# Federal Recall Information

217-A

Safety Recall - Fuel Tee Leaking on Models 567 and 579 2017 emissions vehicles

### Trucks built before 1 January, 2016

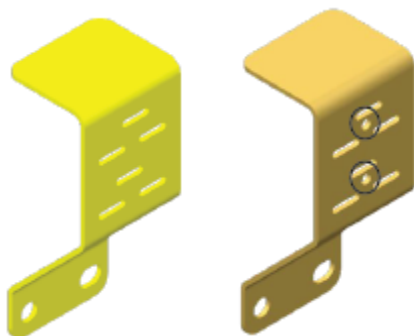
Trucks built before 1 January, 2016 require replacement of the mounting bracket, in addition to replacement of the fuel tees. The original bracket does not have holes for the studs on the replacement fuel tees.

The old bracket on the left has no stud holes as shown on the new bracket on the right.

Fuel tees will be replaced on vehicles equipped with suspect fuel tees. Select vehicles will require a new bracket to be installed. See chassis list below for chassis-specific parts required.
